WARFIGHTER SUPPORT

Independent Expert Assessment of Army Body Armor Test Results and Procedures Needed Before Fielding

Highlights of [GAO-10-119](#), a report to congressional requesters

Figure 4: Graphic Representation of the Difference between the Point of Aim and the Deepest Point

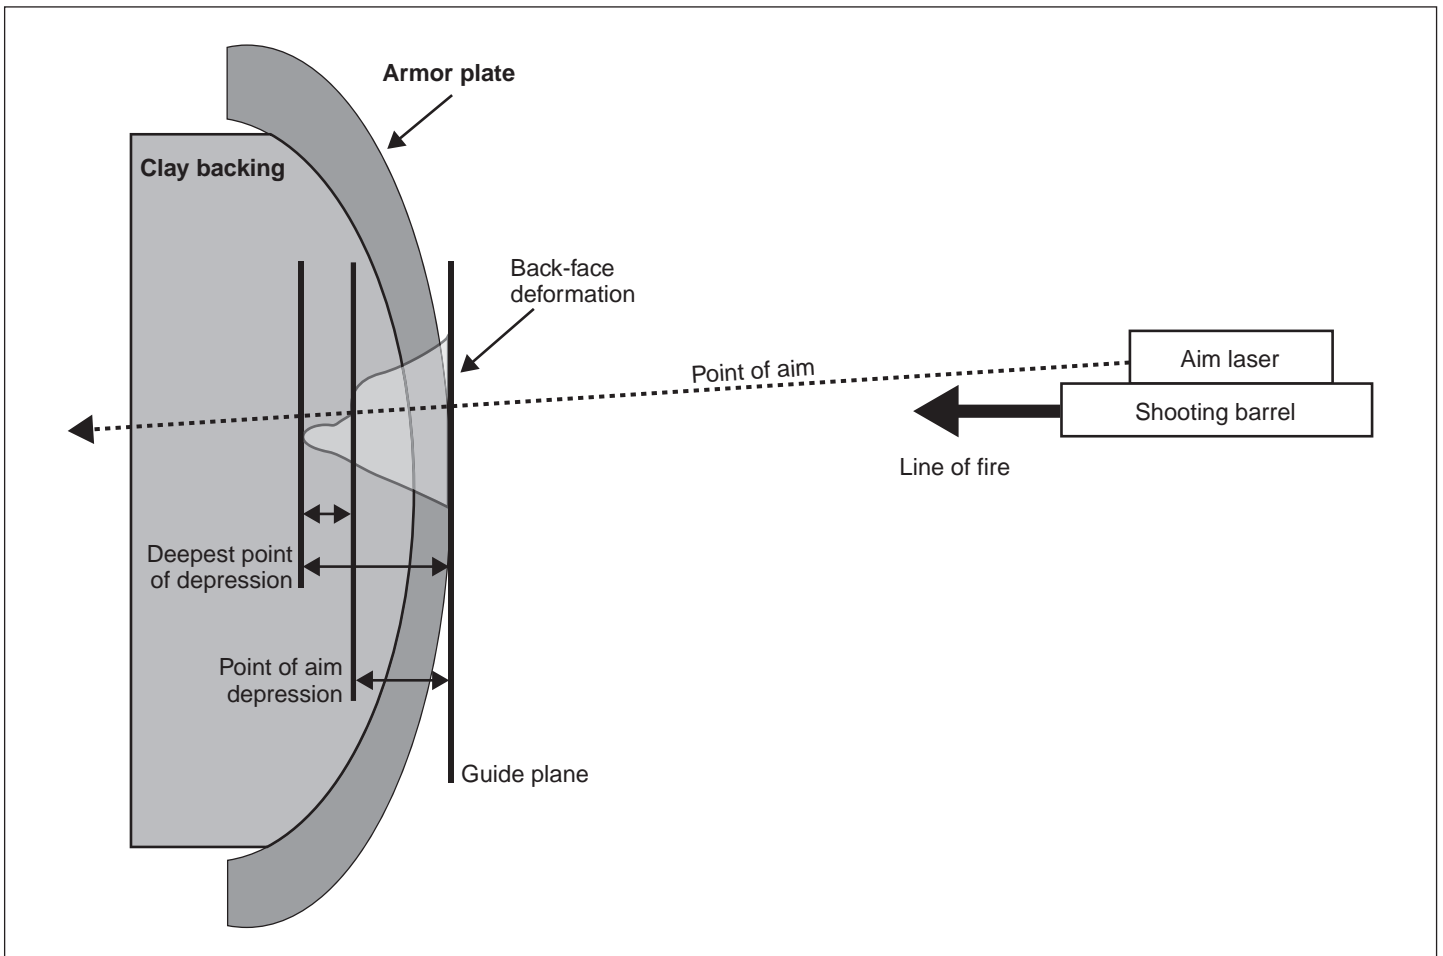
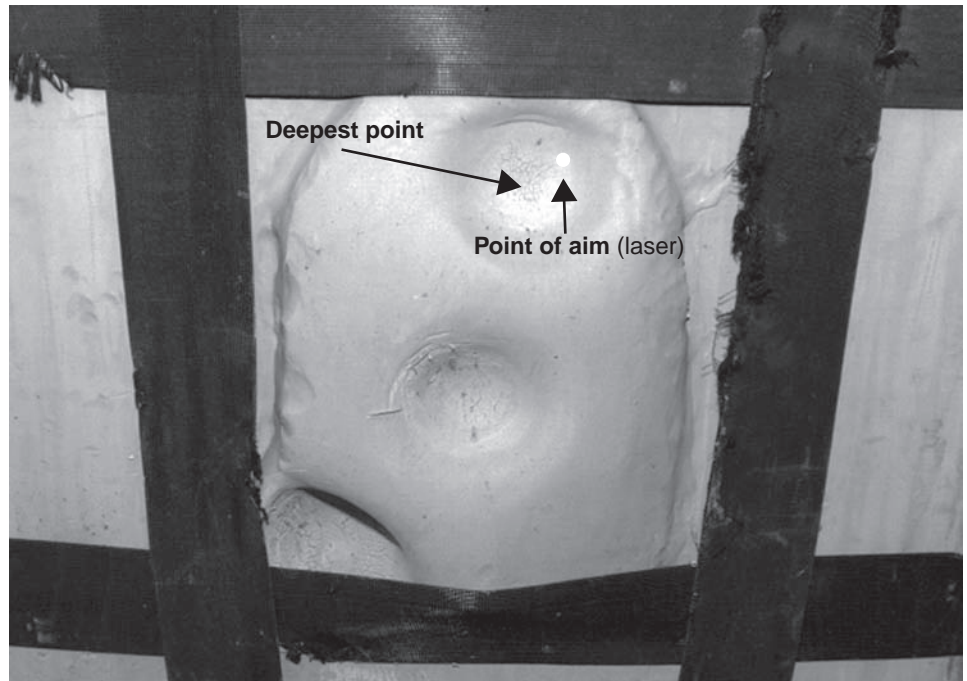
deformation is to be measured at the deepest point of the depression in the clay backing. This measure indicates the most force that the armor will allow to be exerted on an individual struck by a bullet. According to Army officials, the deeper the back-face deformation measured in the clay backing, the higher the risk of internal injury or death. During approximately the first one-third of testing, however, Army testers incorrectly measured deformation at the point of aim, rather than at the deepest point of depression. This is significant because, in many instances, measuring back-face deformation at the point of aim results in measuring at a point upon which less ballistic force is exerted, resulting in lower back-face deformation measurements and overestimating the effectiveness of the armor. The Army's subject matter experts on the Integrated Product Team were not on the test lanes during testing and thus not made aware of the error until approximately one-third of the testing had been completed.

When members of the Integrated Product Team overseeing the testing were made aware of this error, the Integrated Product Team decided to begin measuring at the deepest point of depression. When senior Army leadership was made aware of this error, testing was halted for 2 weeks while Army leadership considered the situation. Army leadership developed many courses of action, including restarting the entire Preliminary Design Model testing with new armor plate submissions, but ultimately decided to continue measuring and scoring officially at the point of aim, since this would not disadvantage any vendors. The Army then changed the test plans and modified the contract solicitation to call for measuring at the point of aim. The Army also decided to collect deepest point of depression measurements for all shots from that point forward, but only as a government reference. During the second two-thirds of testing, we observed significant differences between the measurements taken at the point of aim and those taken at the deepest point, as much as a 10-millimeter difference between measurements. As a result, at least two of the eight designs that passed Preliminary Design Model testing and were awarded contracts would have failed if the deepest point of depression measurement had been used. Figures 4 and 5 illustrate the difference between the point of aim and the deepest point.

Figure 6: Tears in Kevlar Backing Material after a Penetration of the Plate

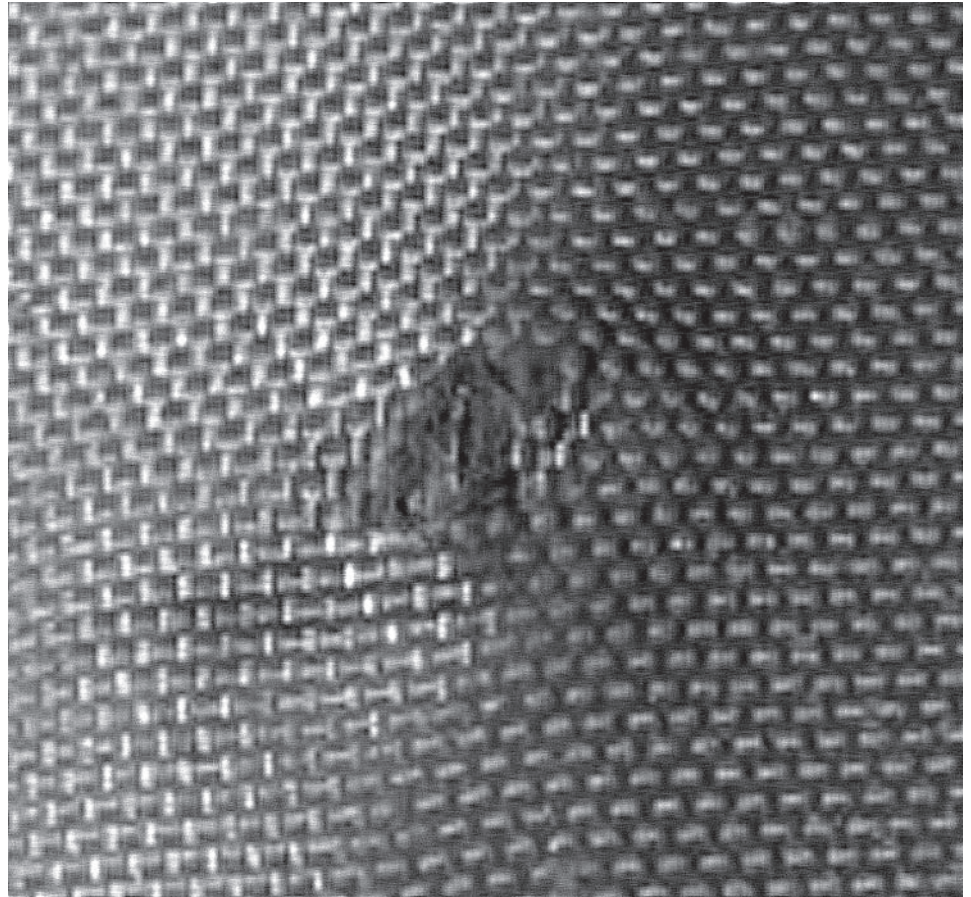
the testing protocols or otherwise documented but said that Army testers discussed this before First Article Testing began. Figure 6 shows the tear in the fibers of the rear of the plate in question.

In addition to the DOD acknowledgement that an Aberdeen Test Center subject matter expert found particles on the soft body armor, more convincing evidence is the picture of the subject plate. Figure 6 of our report clearly shows the tear in the fibers that were placed behind the plate in question allowing the penetration of the particles found by the Aberdeen Test Center subject matter expert. These particles can only be fragments of the projectile or fragments of the armor material that passed into the soft under garment used behind the protective inserts (plates), confirming our observations of the event and the subsequent incorrect scoring. The shot should have been scored a complete penetration, and the penalty incurred would have caused the design in question to fail First Article Testing.

DOD also did not agree with our finding that a penetration of a plate was improperly scored. DOD did agree that figure 6, which shows the tear in the Kevlar fibers of the rear of the plate in question, appears to show evidence of a perforation and that an Aberdeen Test Center ballistics subject matter expert found particles in the soft backing material behind the plate. Nevertheless, DOD did not concur with our finding because it asserted that no threads were broken on the first layer of Kevlar. However,

Figure 3. BFD Measurement Reference Guide from Purchase Description.

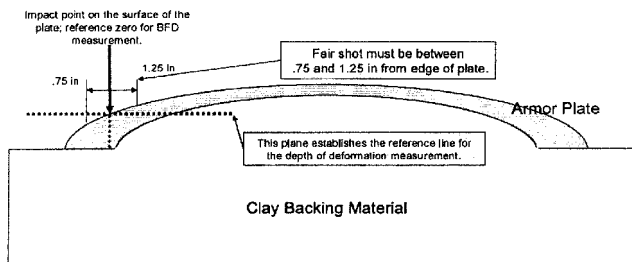
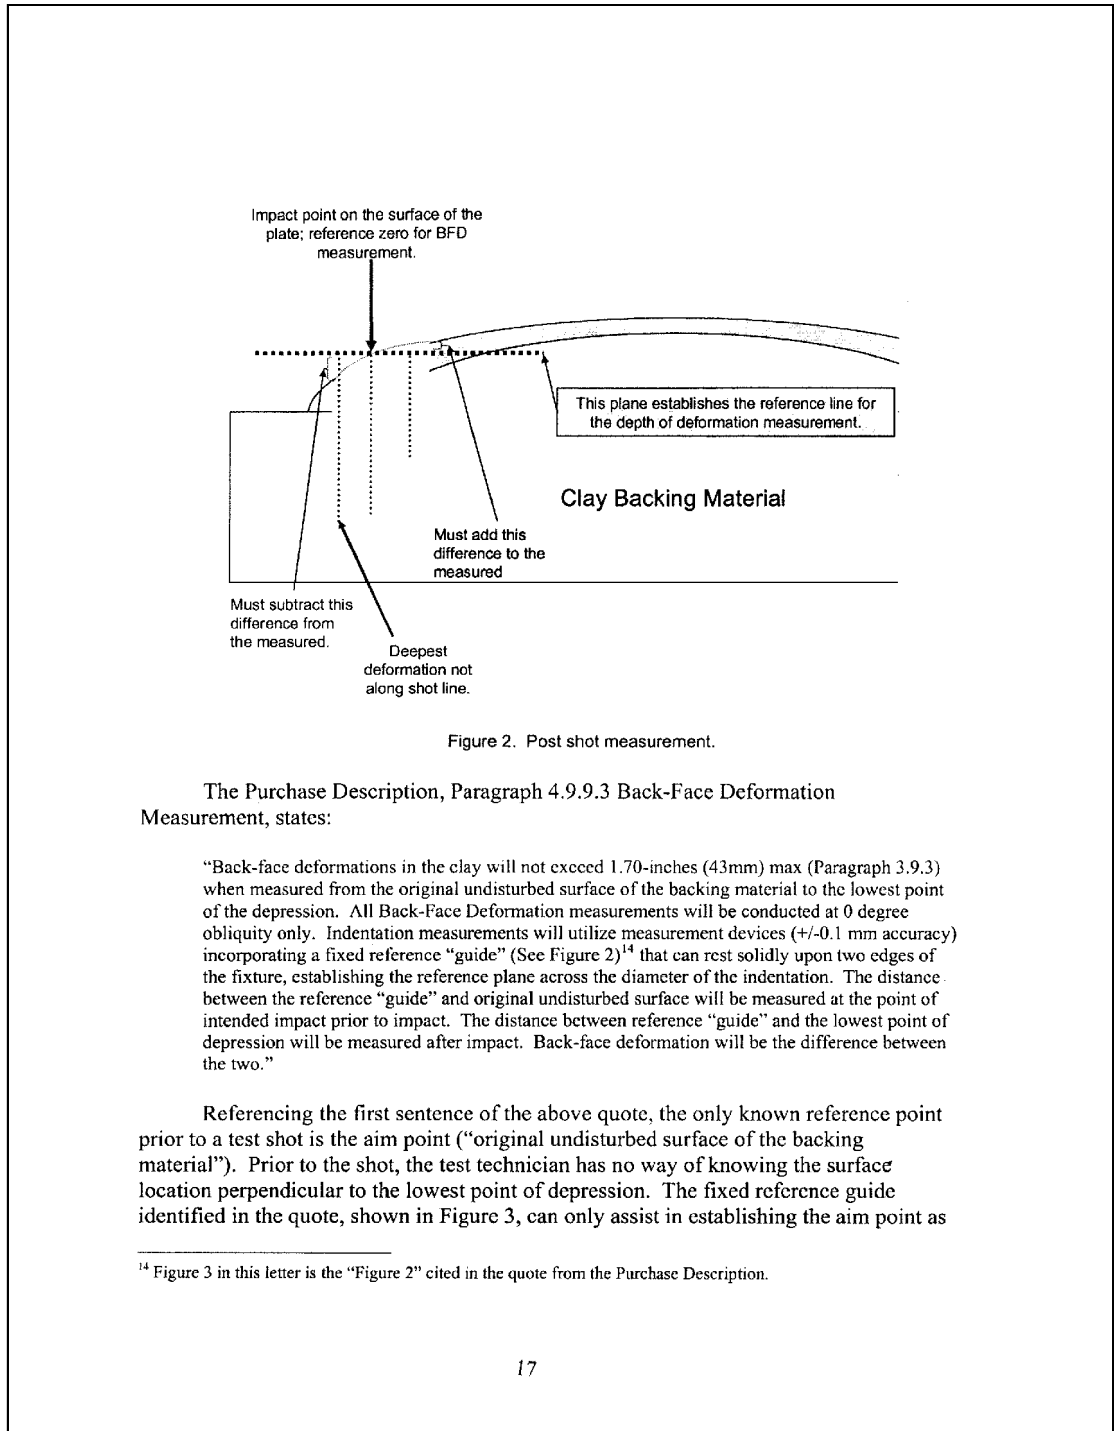
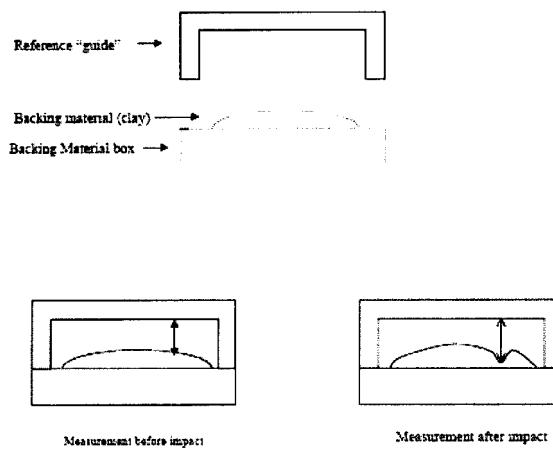
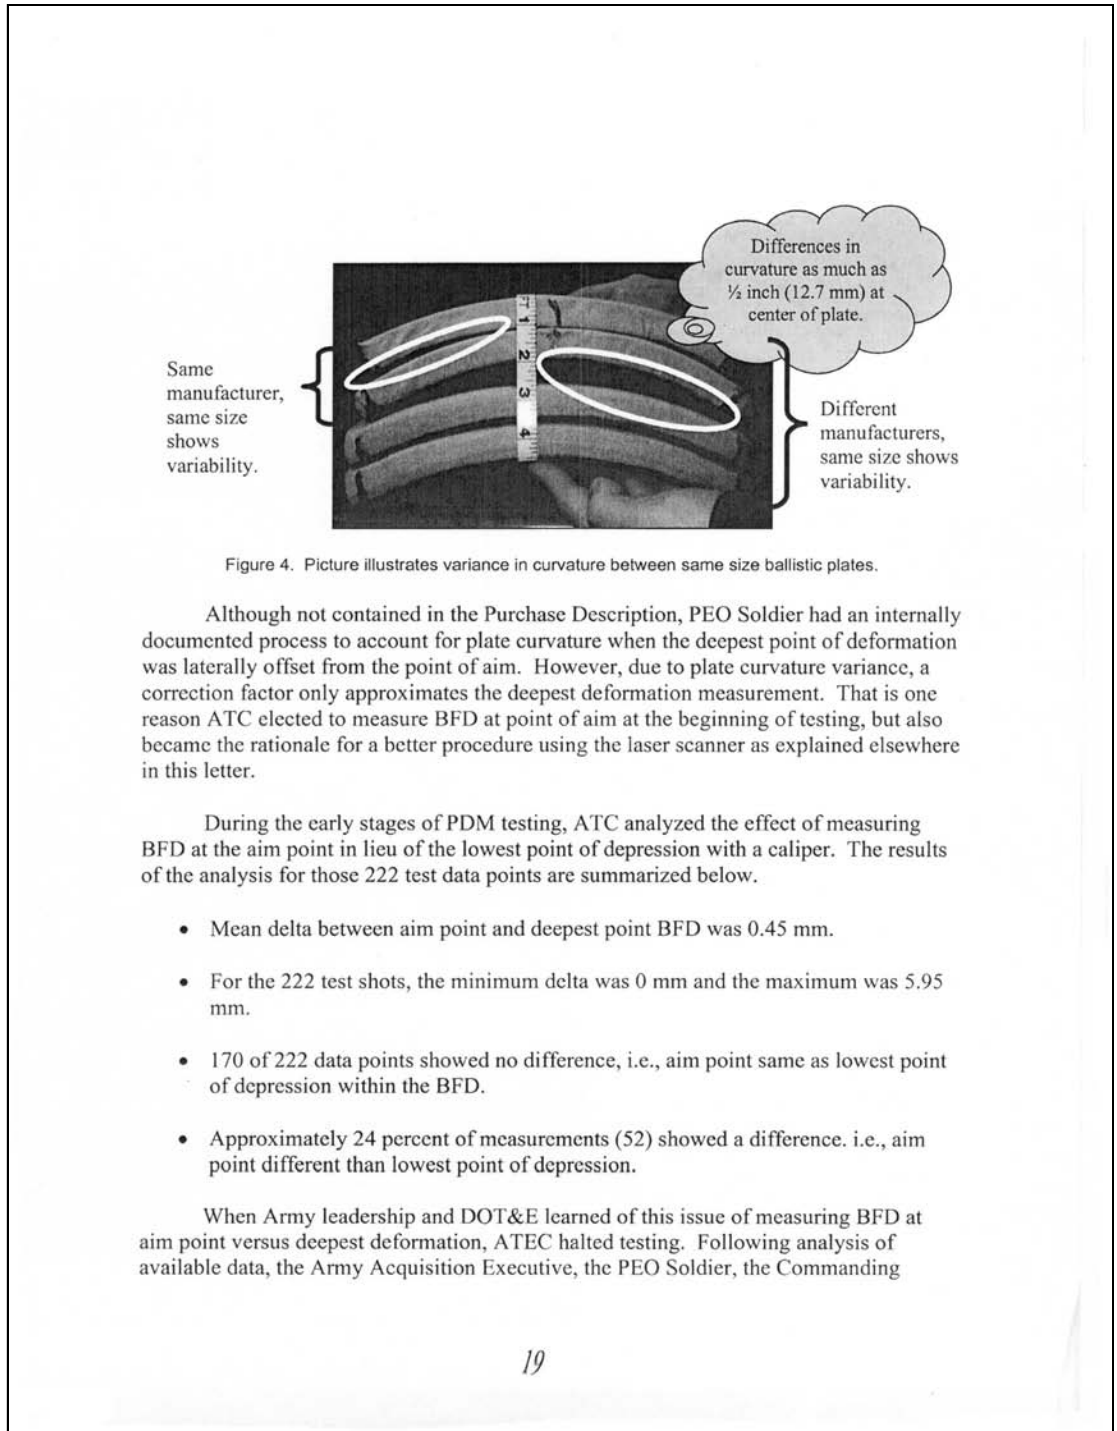
Response: Though ATC deviated from the test protocol in the Purchase Description regarding measuring BFD at the lowest deformation, Army leadership after a deliberative internal process and in consultation with DOT&E, decided to use the BFD point-of-aim measurement as it was determined to be an accurate and repeatable process that did not bias any vendor's design. The following information highlights the rationale for this decision. For clarity and reference, Figures 1 and 2 depict the geometry associated with this issue. Further discussion follows the figures.

Referencing the first sentence of the above quote, the only known reference point prior to a test shot is the aim point (“original undisturbed surface of the backing material”). Prior to the shot, the test technician has no way of knowing the surface location perpendicular to the lowest point of depression. The fixed reference guide identified in the quote, shown in Figure 3, can only assist in establishing the aim point as

There are two important considerations pertaining to the guidance in the Purchase Description: First, the lowest point of depression must be subjectively selected by a test technician, and second, measuring perpendicular from the point selected as the lowest point of depression to the reference guide provides the distance between that point and the original undisturbed surface at the aim point, not the original undisturbed surface perpendicular to the lowest point of depression, which is what is required to obtain an accurate measurement. Using the technique described, an accurate measurement can only be made if the measurement is made on a flat surface with a uniform original undisturbed reference surface. However, since the plates are curved and the radius varies between vendor plates and even within vendors for same plate sizes, as shown in Figure 4, the only point at which an accurate measurement can be made with the described measuring device is the aim point.

Figure 5. Results of ATC analysis of test results for all vendor designs against the most formidable threat.

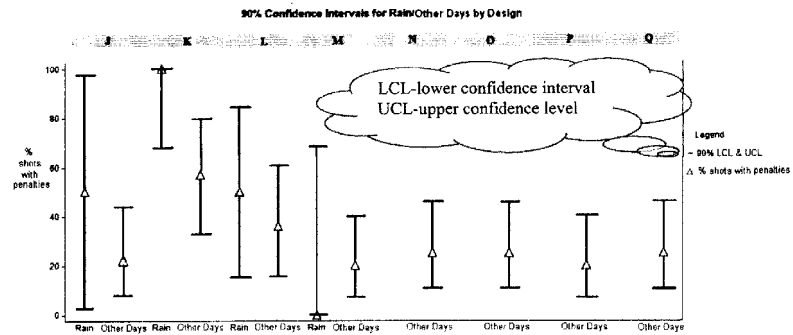
ATC analysis also shows that the poor performance of the vendor's design in question was attributed to its marginal performance against the most formidable threat round under test, not to a brief time (seconds) of exposure to a “constant heavy, cold rain and low temperatures” or the effects of rain on the clay surface. Statistical analyses were performed on the test results for all designs including those tested on November 13, 2008. The result of that analysis, as shown in Figure 5, indicate Design K was the weakest

design on days with no rain as well as days with rain. Design K had a 70 percent failure rate during all testing against the most formidable threat. Even when excluding the rain day data, which was when that design was subjected to the most stressing tests, the design still had a 57 percent failure rate.

Figure 6. Front face of shoot pack for the test in question.

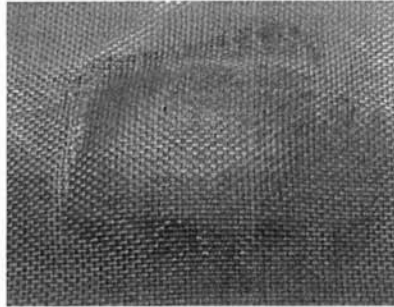
Response: This information appends that provided in the earlier discussion of this issue. While Figure 6 of the GAO report appears to show evidence of a perforation on the rear of the test plate in question, by the definition in the Purchase Description, a complete perforation is scored based upon the damage to the soft armor shoot pack directly behind the ballistic test plate. The front (face immediately behind the plate under test) of the shoot pack in question is shown in Figure 6 of this response, located below. Though deformed, the damage does not constitute a complete perforation of the plate according to the definition in the Purchase Description.
